**MODIFICATION REQUEST:
Residential Subdivision
Highview Drive, Dolphin Point
05_0024 MOD 1**

Director-General's
Environmental Assessment Report
Section 75W of the
Environmental Planning and Assessment Act 1979

July 2013

Figure 2: Proposed Roundabout Location – Dolphin Point

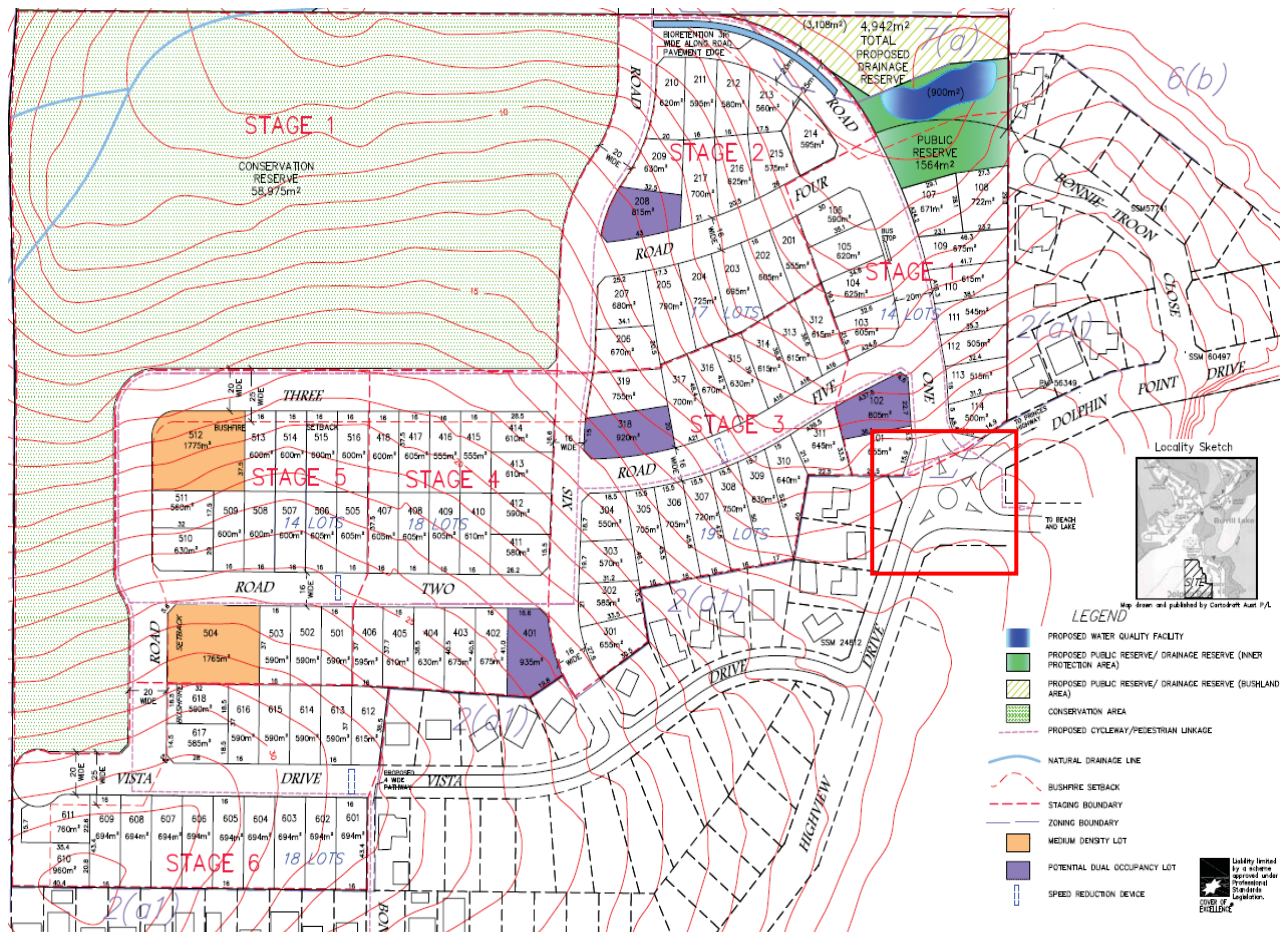
Council objected to the proposed modification of Condition B19(4). Council suggested as an alternative that the final sentence of clause (4) which specifies the dimensions required of the roundabout be deleted. Council considered that the design criteria of the future roundabout will ultimately need to conform to the relevant Austroads standards, and that it is unnecessary to define the detailed roundabout dimensions as part of the condition.

The department concurs with council's advice and considers the future roundabout design and specific dimensions can be agreed upon between the proponent and council at such time the roundabout is to be constructed. This provides the proponent with a degree of flexibility as to the future design of the roundabout. Condition B19(4) is therefore amended to remove reference to the specific dimensions of the roundabout, with the future design of the roundabout to be prepared in consultation with council and in accordance with the relevant Austroads standards prior to the issue of a construction certificate.

Figure 3: Dolphin Point Road Link connection to the Princes Highway (source: Nearmap)

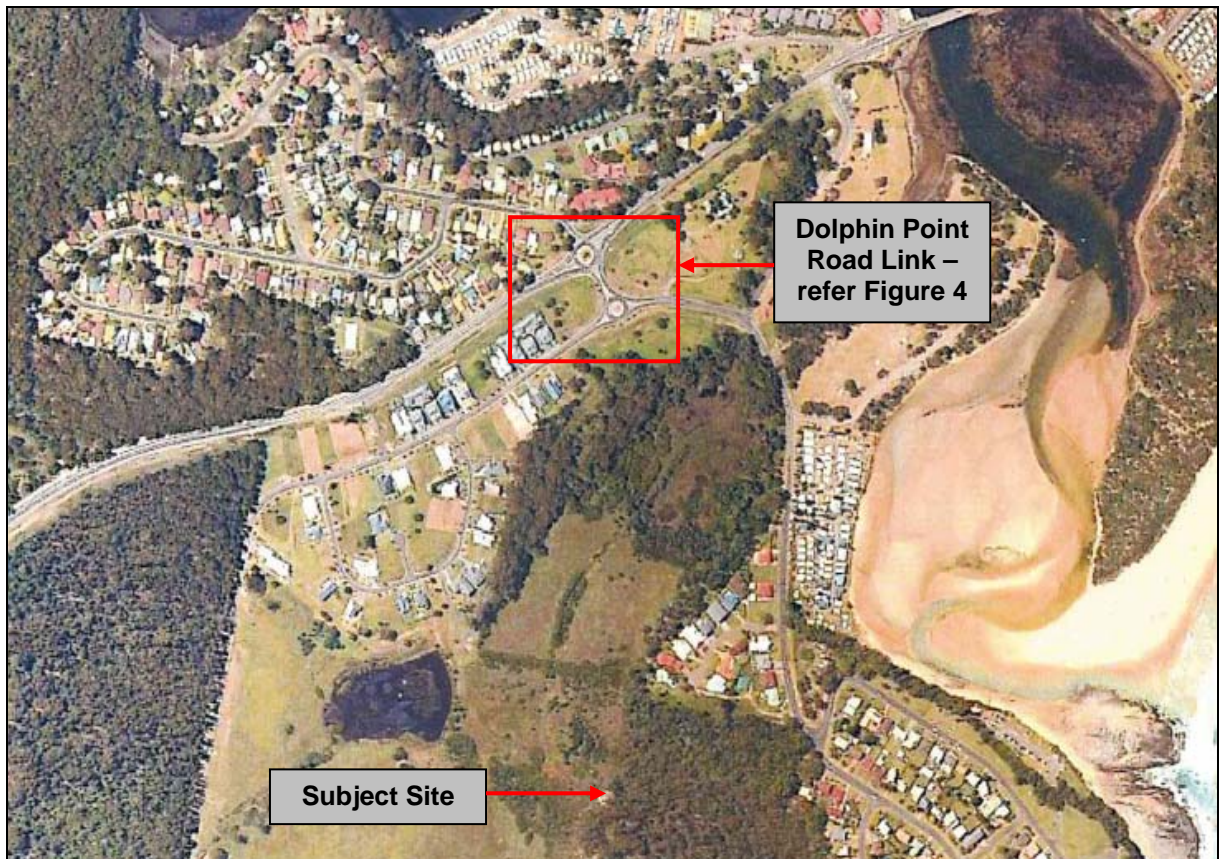
Council objects to the deletion of the condition on the grounds that the link road between the two existing roundabouts does not provide sufficient storage for vehicles using the intersection, and that the increased traffic generation as a result of the subdivision increases the need for the left-turn lane. In particular, council notes that there is only 40m-50m of storage length (6 to 7 vehicles) between the roundabouts without obstructing the internal roundabout operation. This was the basis upon which the condition was originally recommended by council and supported by the department.

Council objects to the deletion of Condition B21. The reason for the condition is to recognise the increase in traffic entering the Highway intersection that has a single lane entry into the roundabout. The short length of the link road between two roundabouts does not provide storage of vehicles using the intersection so traffic wanting to turn left heading south will be delayed until vehicles entering and turning right have done so. The subject subdivision traffic generation increases the need for the work.

The department notes that the proponent has not presented an argument that the left-turn lane is unnecessary on the basis of predicted traffic volumes. Furthermore, no revised traffic studies or analysis beyond what was submitted as part of the original application has been submitted as part of the modification. The department's assessment of the demand to provide the left-turn lane in the first instance was adequately considered as part of the original application. The department was satisfied that there would be sufficient traffic generated by the proposal to require the left turn lane. In the absence of any revised traffic studies or analysis, the department does not support deletion of Condition B21 and considers the left-turn lane is required to be constructed as part of the development.

Figure 6: Proposed Access Point to Lots 108 and 109 – Bonnie Troon Close, Dolphin Point

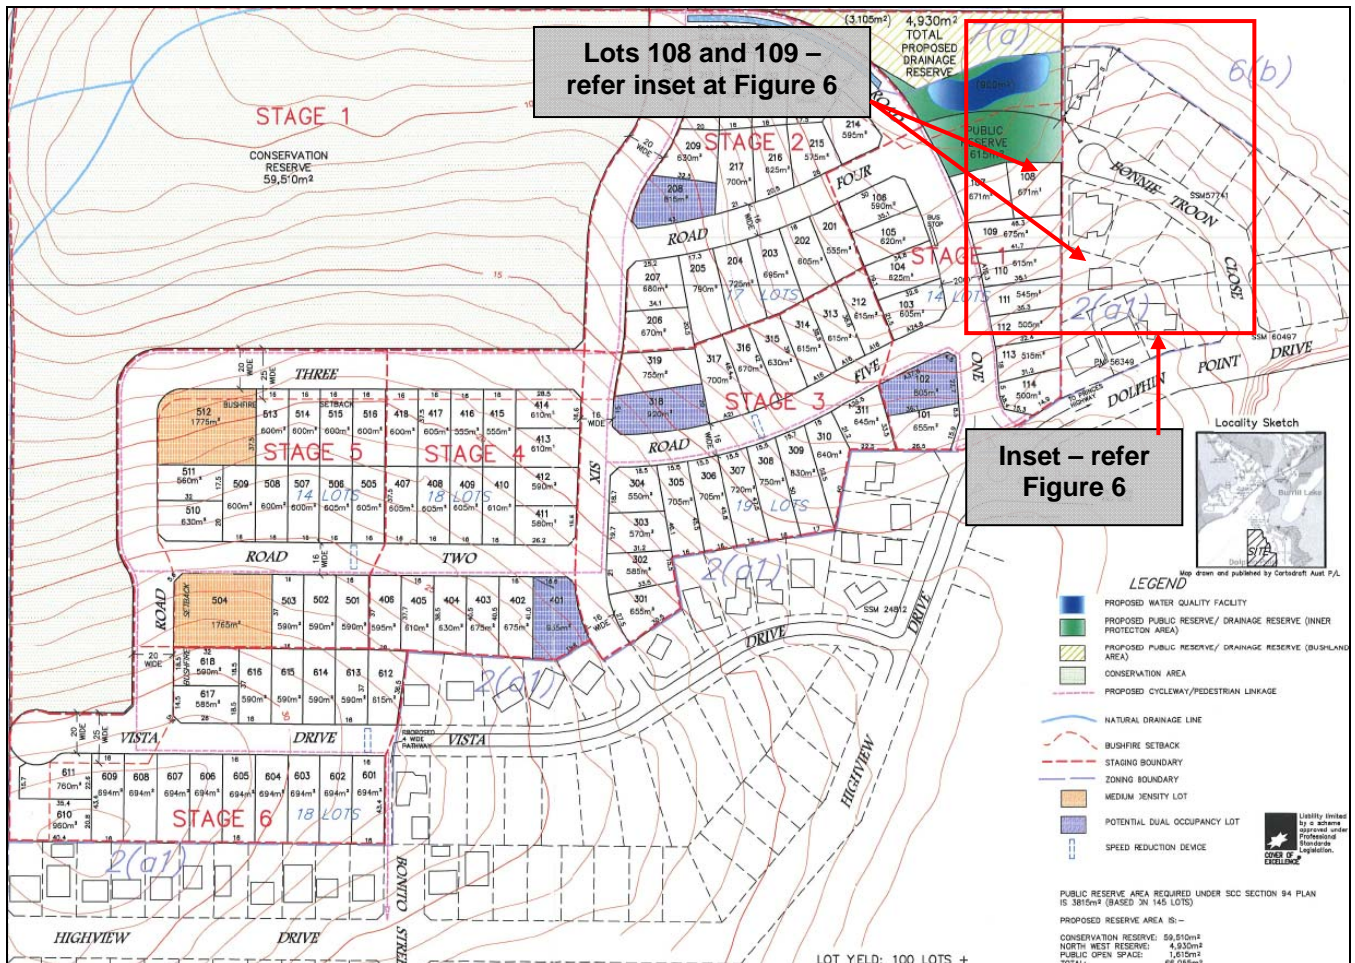
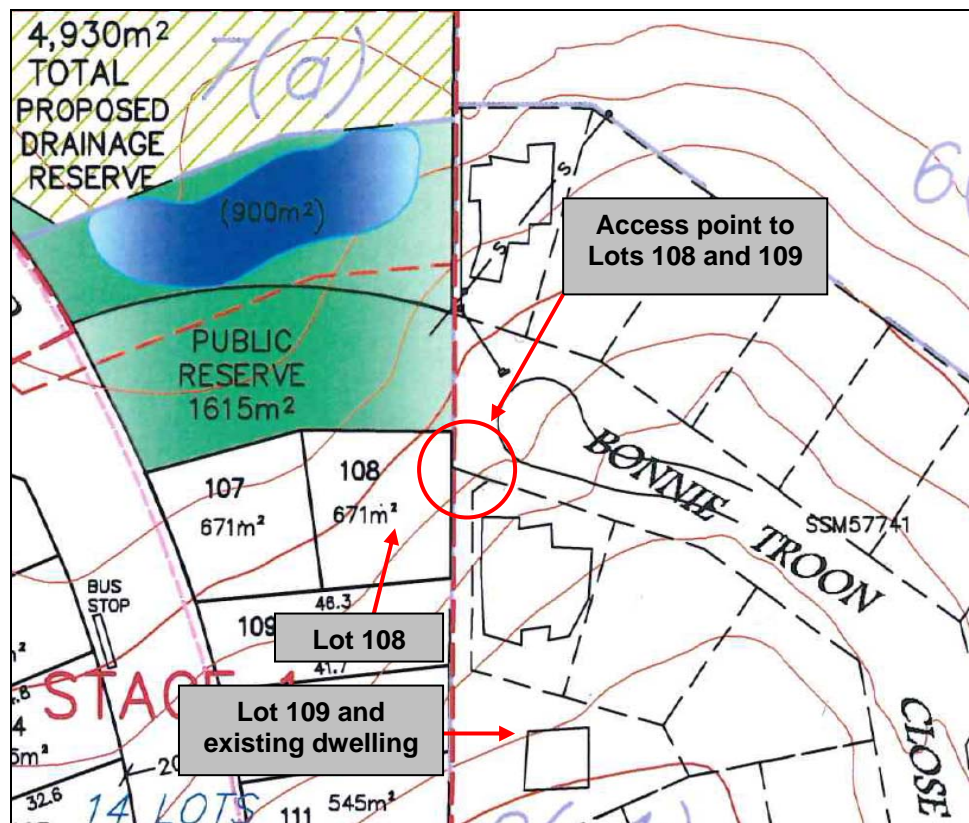
Council raised concern regarding the proposed access arrangement to Lot 108 which fronts Bonnie Troon Close and is proposed to be developed as part of Stage 1. The subdivision layout, as approved, requires Lot 108 to share the existing driveway crossing servicing Lot 109 DP 817218 (Lot 109 does not form part of major project 05_0024, but adjoins the site's northern boundary and contains an existing dwelling). **Figure 5** shows the location of Lots 108 and 109. **Figure 6** shows the existing point of access and location of the existing dwelling at Lot 109.

Council advised that Lot 109 has a private driveway crossing that is to remain untouched and therefore requested an independent vehicle crossing of at least 10m in width be provided for Lot 108. The proponent did not consider there to be any issue with two properties sharing a single access driveway. Nonetheless, the proponent advised that a 10m frontage width to Lot 108 could be achieved through a reduction of the adjoining public reserve immediately to the west. Lot 108 would need to be increased by approximately 51m² to achieve the 10m frontage, thus reducing the public reserve area from 1615m² to 1564m². Council has indicated support for the proposed increase of Lot 108. The department is also of the view that Lot 108 and Lot 109 should have independent access points. The proponent subsequently submitted a revised subdivision plan (revision 8) which reduces the approved public reserve area and provides additional land as part of Lot 108 to provide the necessary access arrangements.
